WATERWHEEL BOOSTER STATION

SAWS Job No. 20-6008

ADDENDUM NO. 3

March 4, 2021

SHEET NO. **E2**

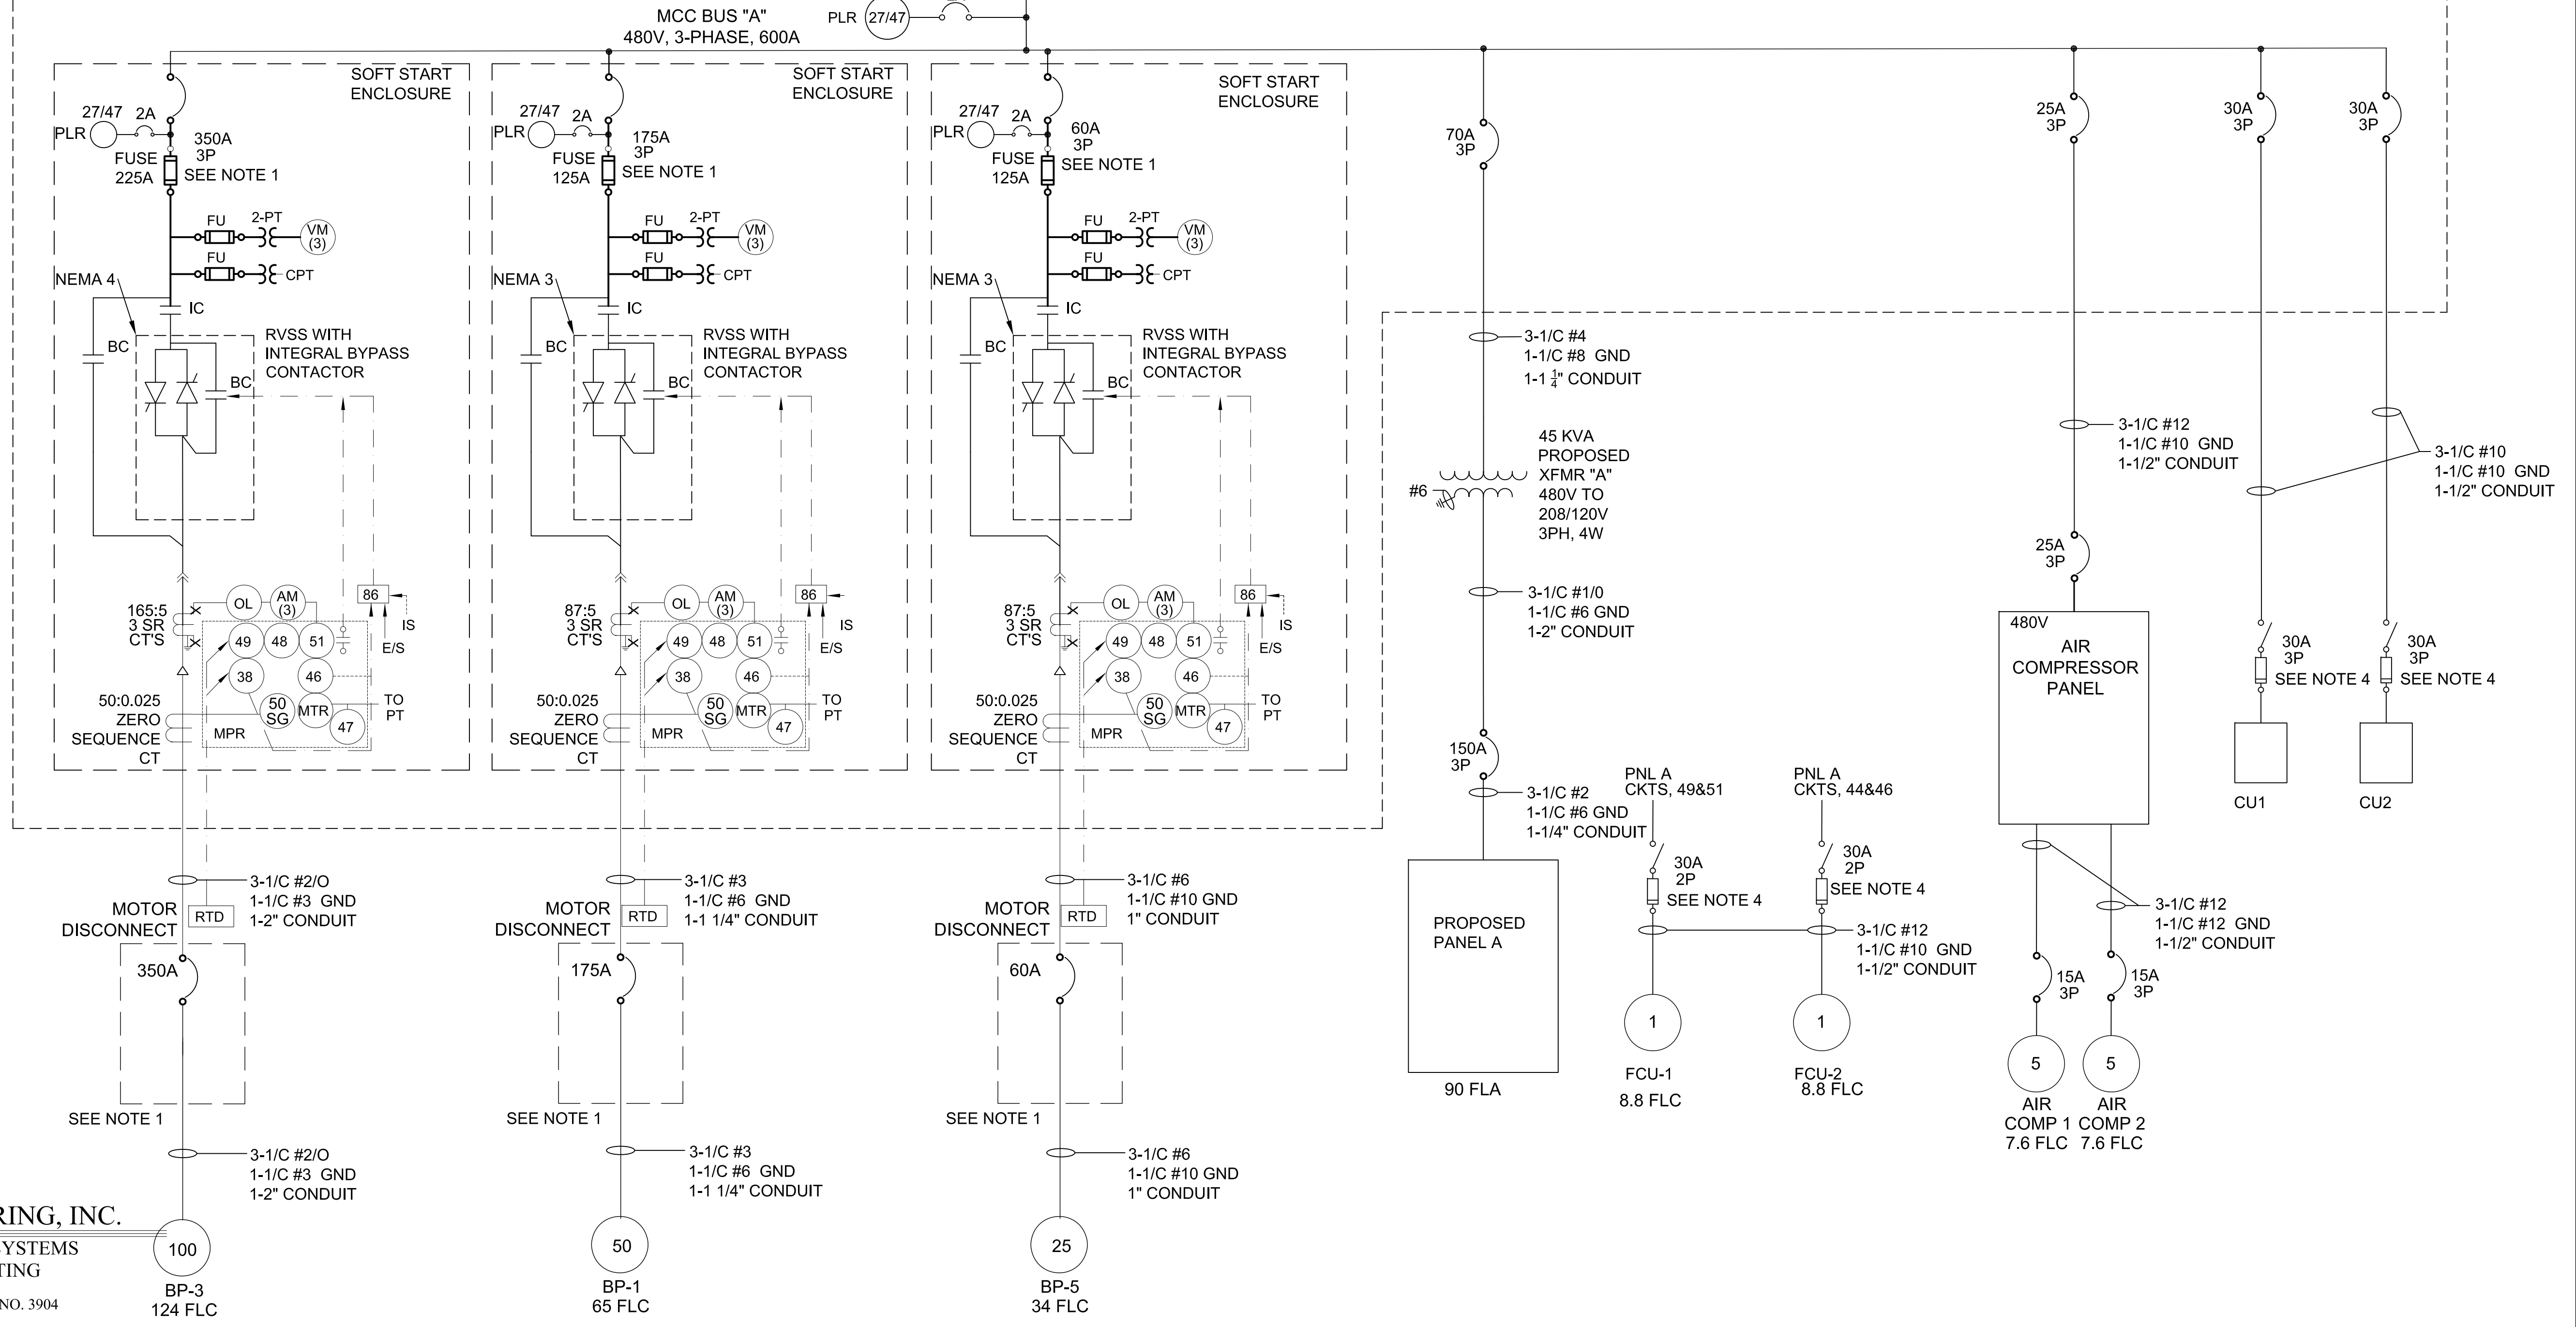
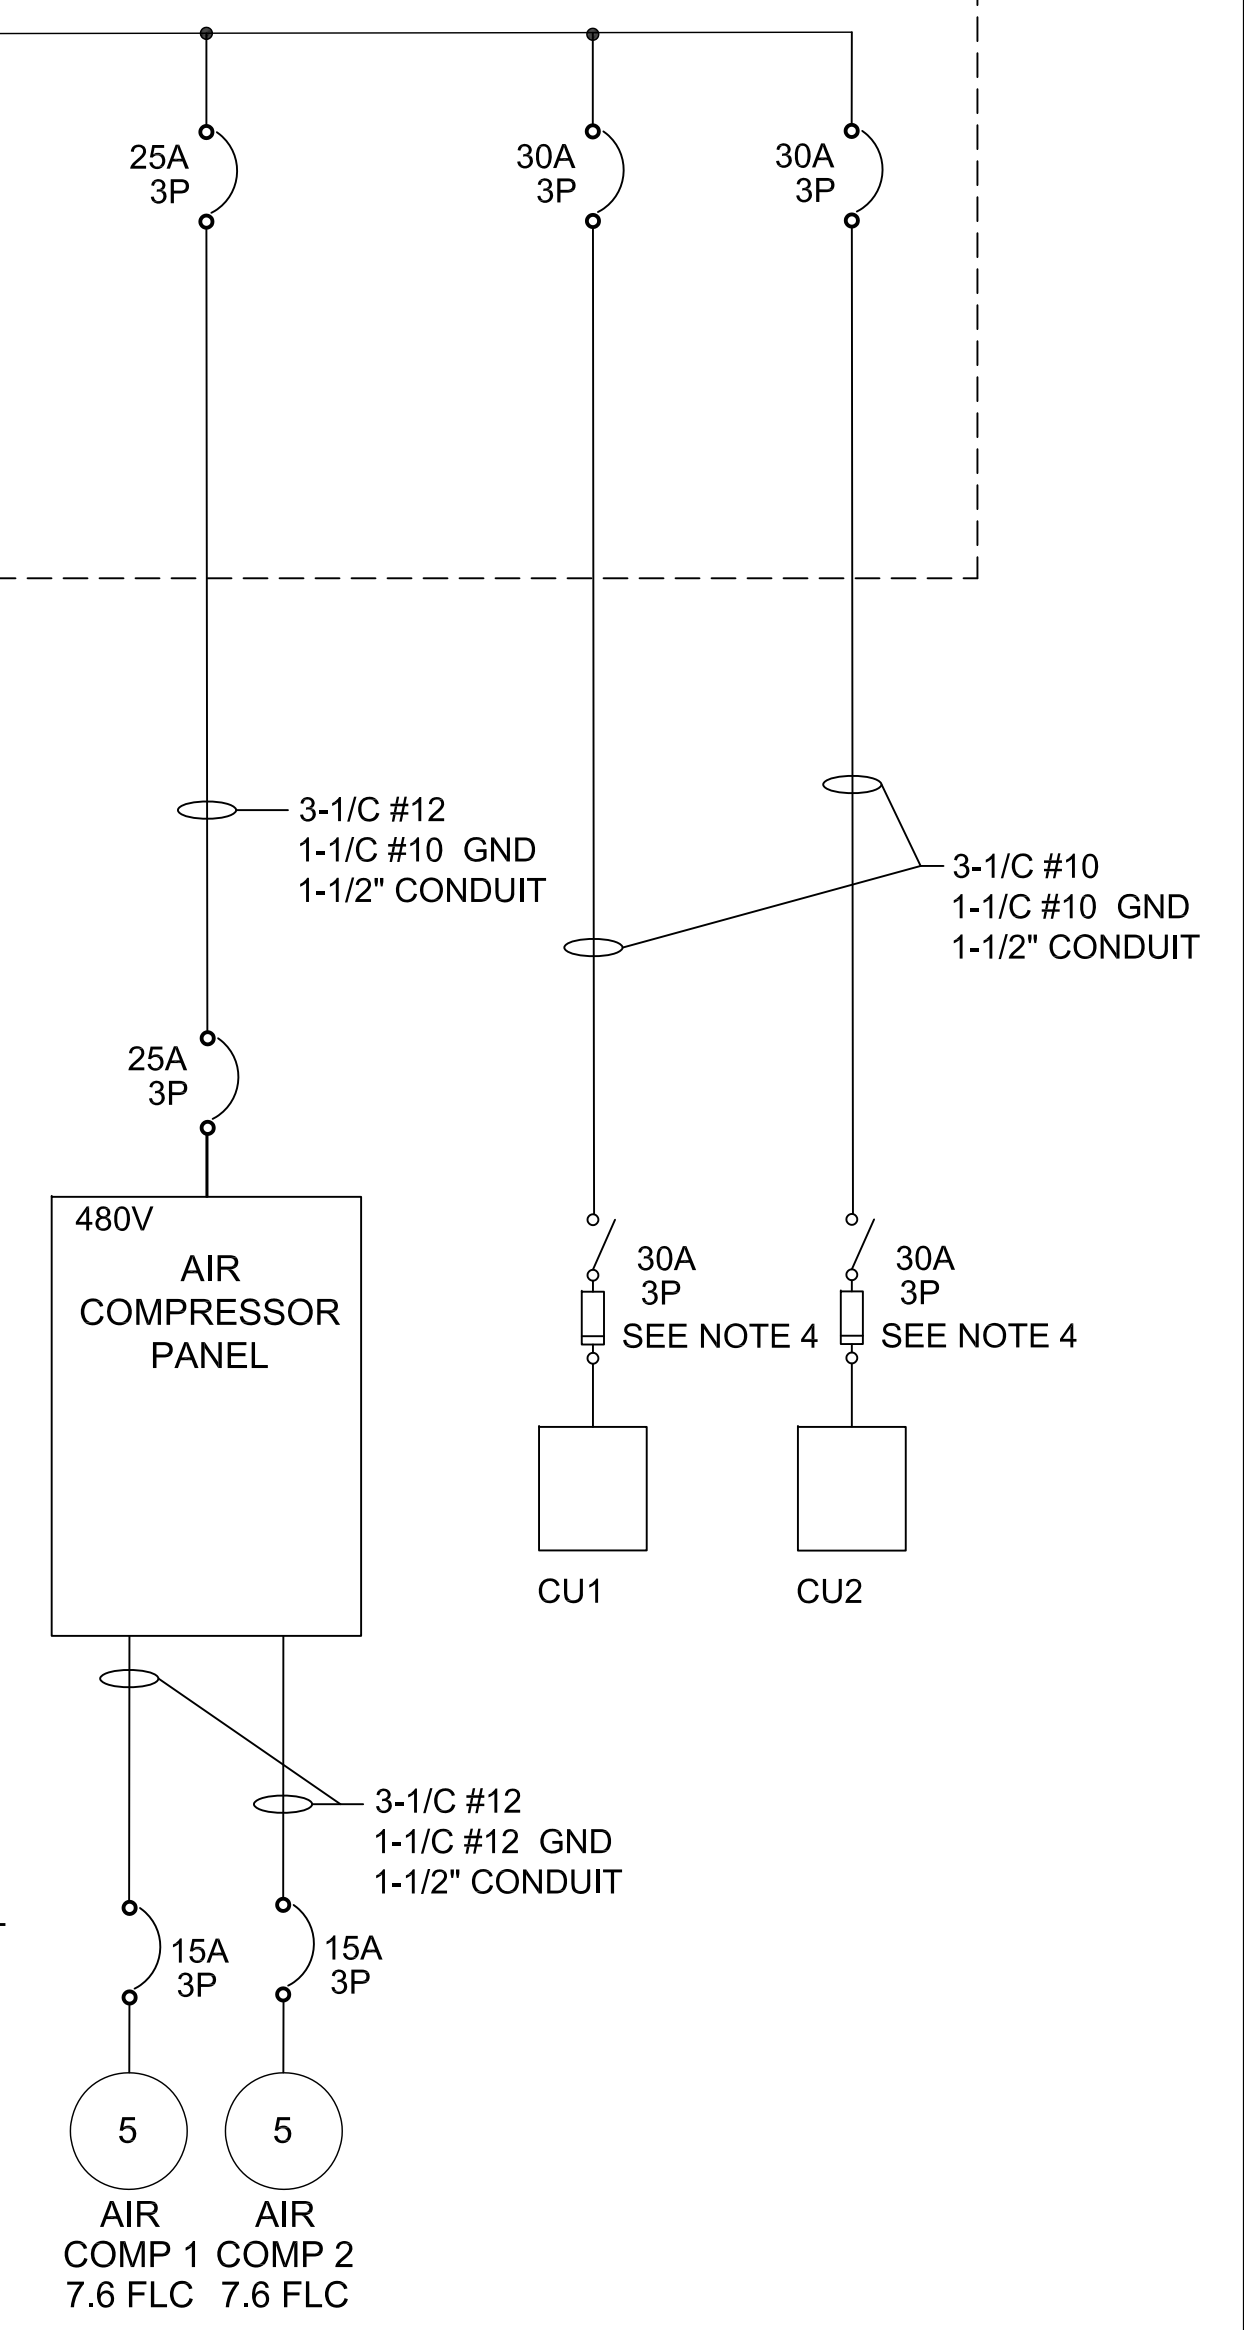
QUESTION 2: Please confirm the feeder size from Generator to Bypass/Isolation Switch is to be 3-1/C #500 KCMIL. We believe this feeder is undersized according to allowable ampacities of conductors as listed within NFPA 70 NEC.

QUESTION 3: Please confirm a duct bank is to be run from new Control Building to Generator Slab. Provide any additional conduits or circuits that are required in addition to generator feeder to Bypass/Isolation Switch.

RESPONSE: Sheet E2 has been revised to show the correct feeder conduit and cable. See "Changes to the Plans" number 2.

RESPONSE: It is confirmed that the duct bank is to be run from the new control building's bypass/isolation switch to the generator. See attached, revised sheet E2 for revised conduits and cables bypass/isolation switch and ATS is one unit. See attached, revised sheets E2 and E24 for any additional conduits/cables that are required in addition to the generator feeder to bypass/isolation switch.

1. Remove and replace sheets E4, E5, and E6, which have been revised to correct the scale.
2. Remove and replace sheets E2 and E24, which have been revised to show the correct feeder conduit and cable.

SHEET NO.
E4

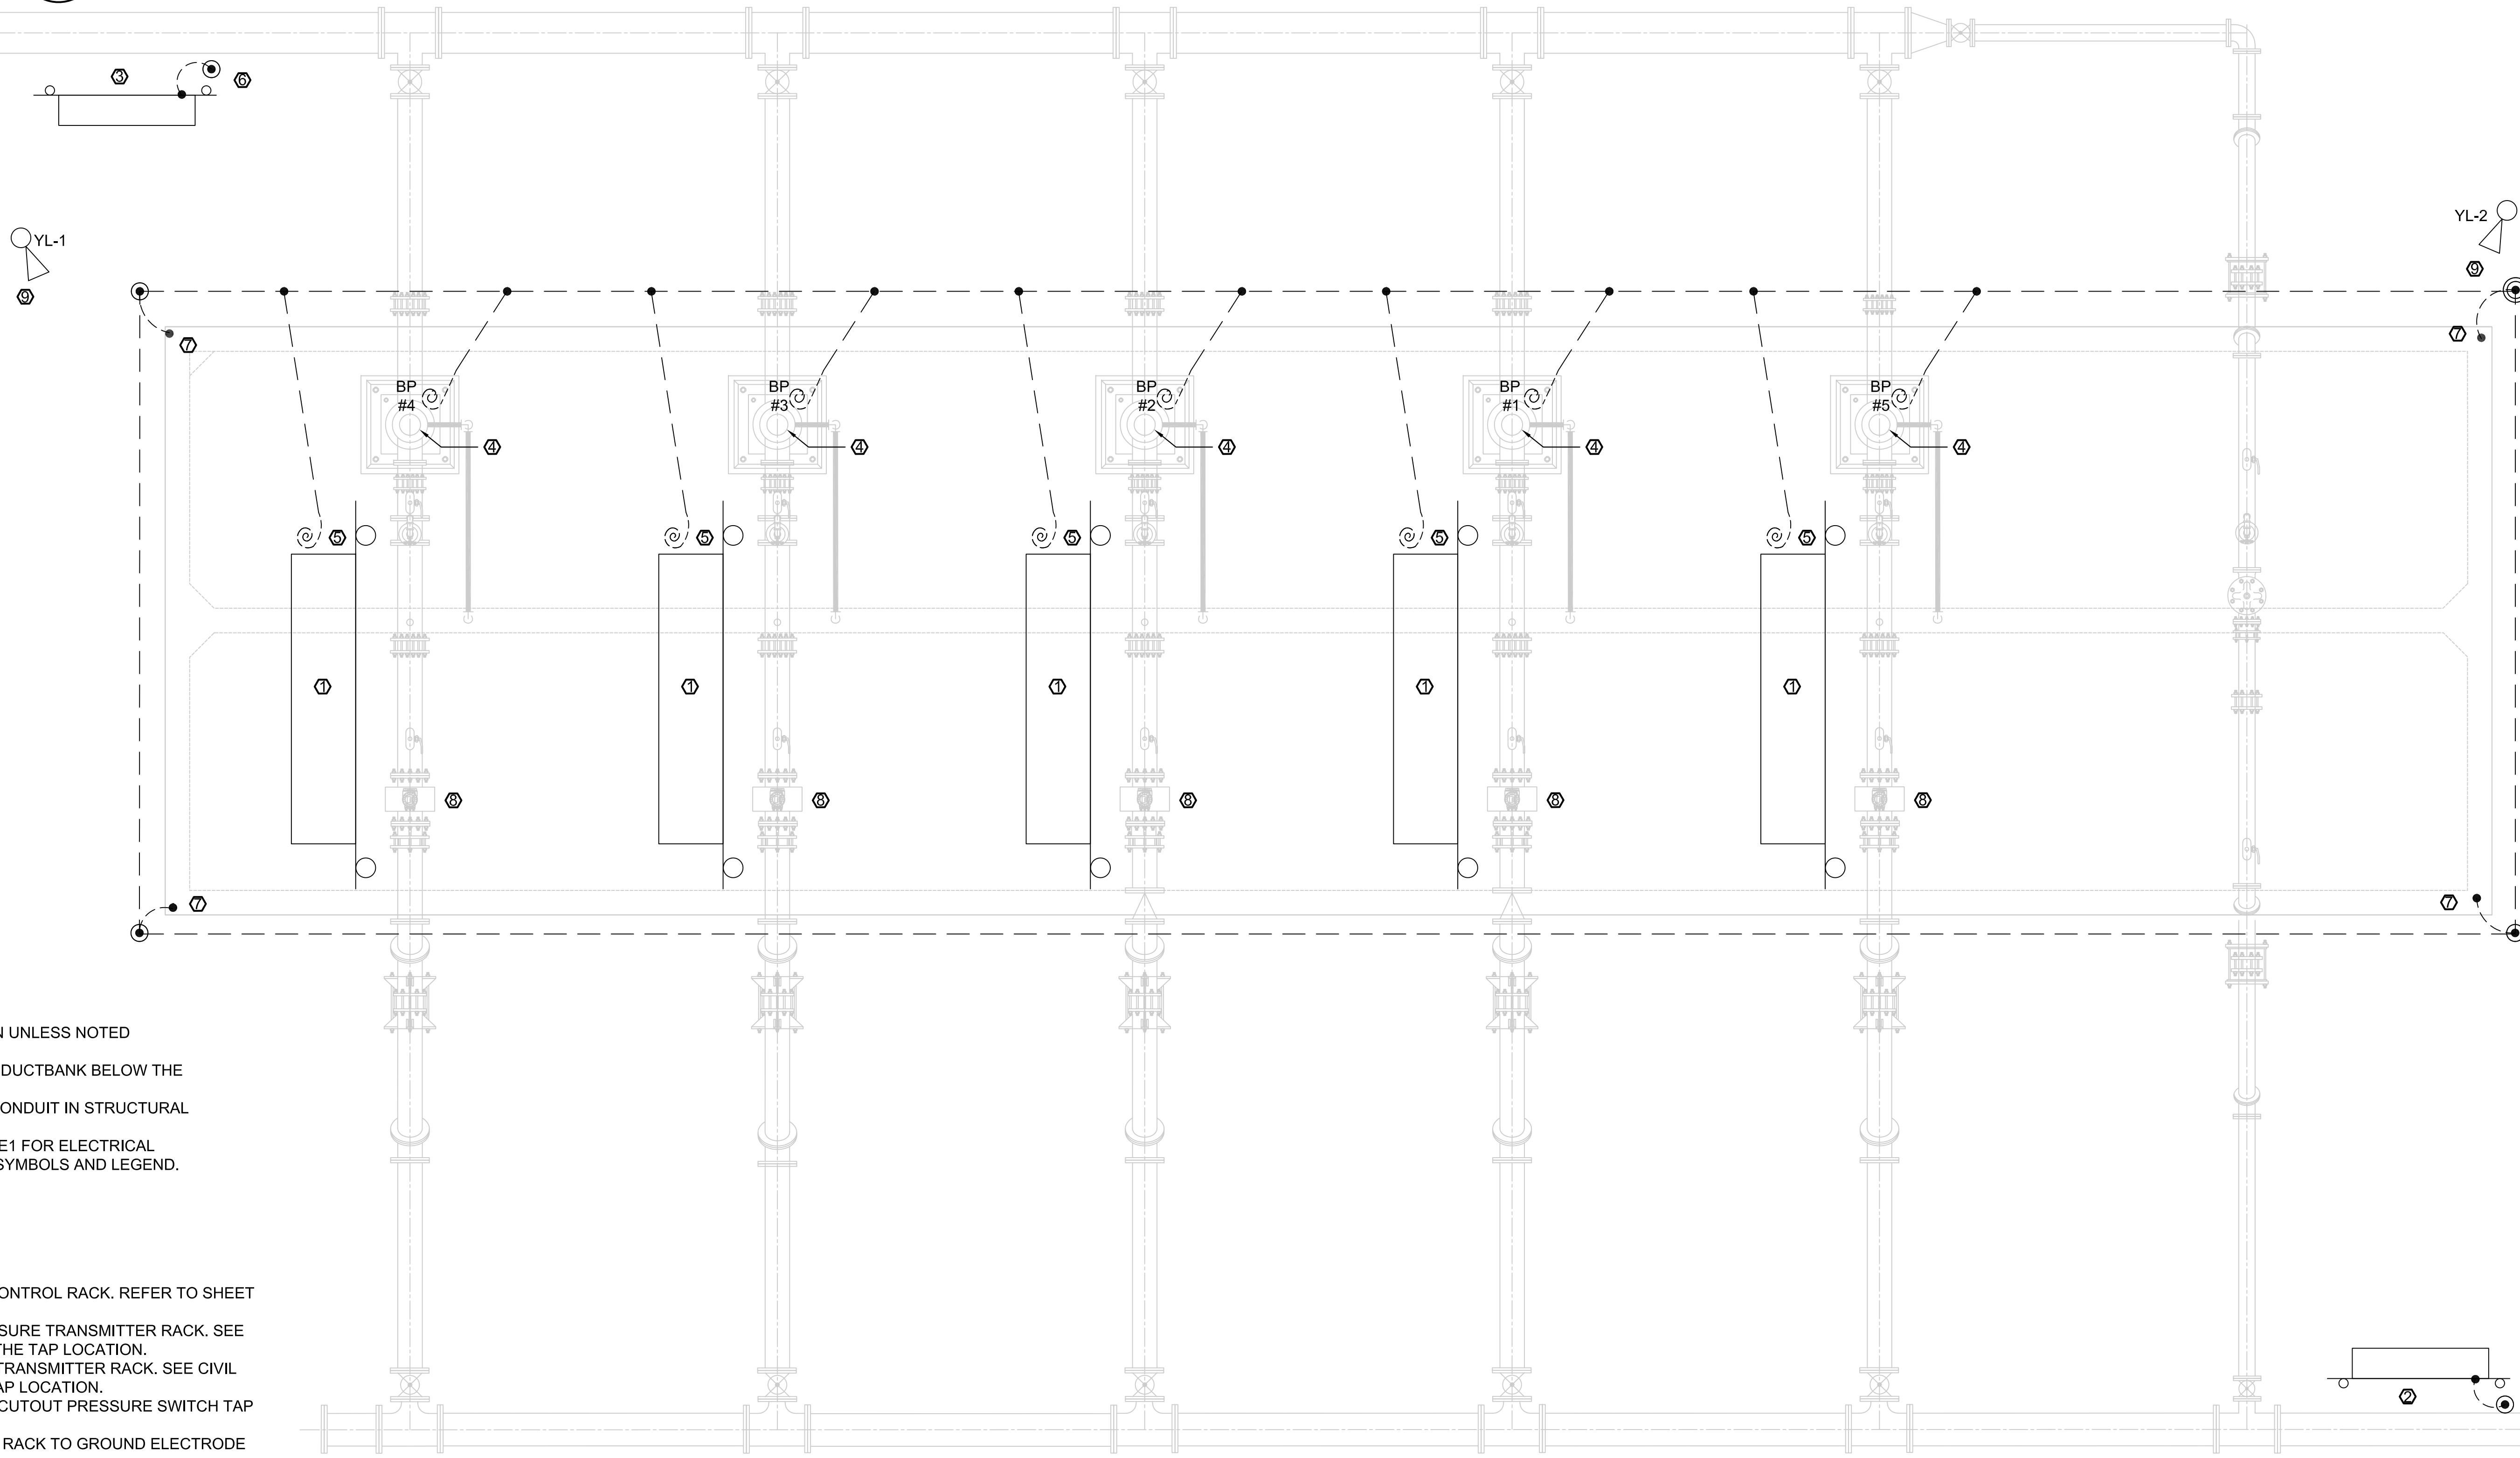
QUESTION 1: Please confirm drawing scale on Sheets E4, E5, and E6. This scale implies the pump pad is approximately 12' in width, while Civil drawings show the width to be 95'.

RESPONSE: The civil drawings are correct. Sheets E4, E5, and E6 have been revised to correct the scale, see "Changes to the Plans" number 1.
